APPLICATION FOR SUBMITTAL OF POST-APPROVAL DOCUMENT

South El Monte High School Modernization

CCD-21

Project Reference: South El Monte High School Modernization Date: 11/21/2023

ELECTRICAL ROOF PLAN - BLDG L

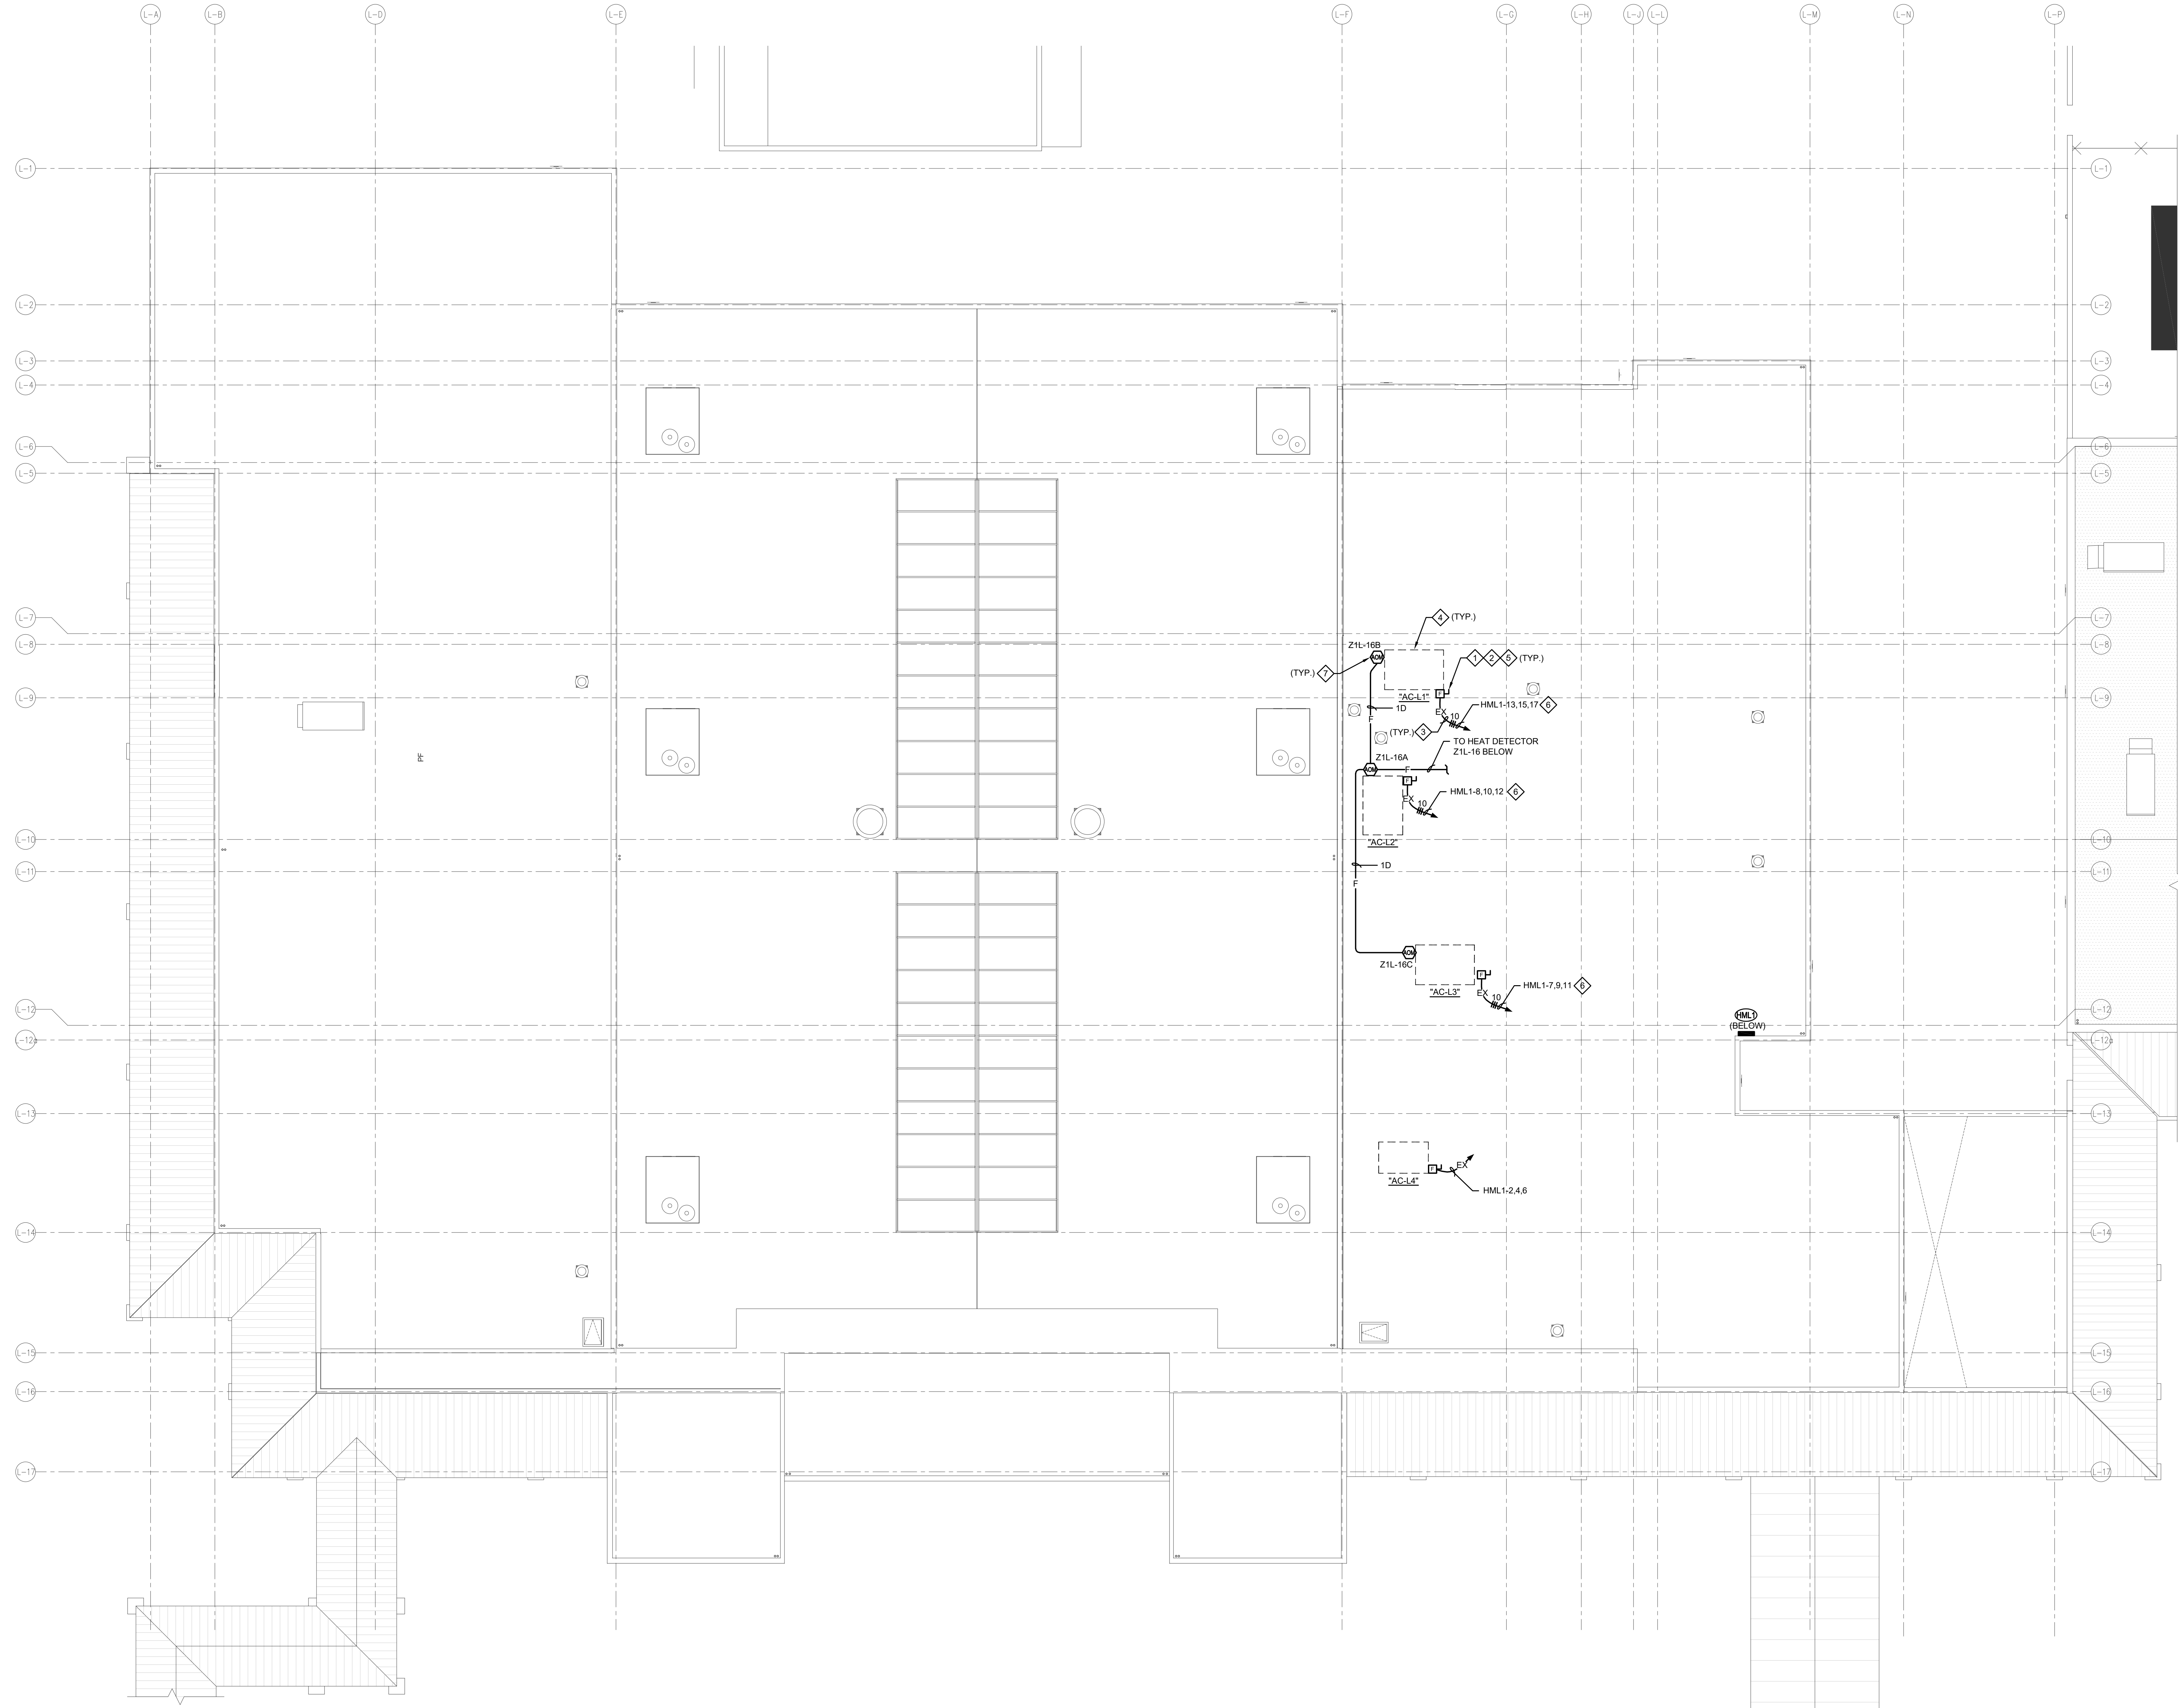
21.14.1. New sheet provided to identify power connections for new replacement HVAC units on the roof above the existing food service area.
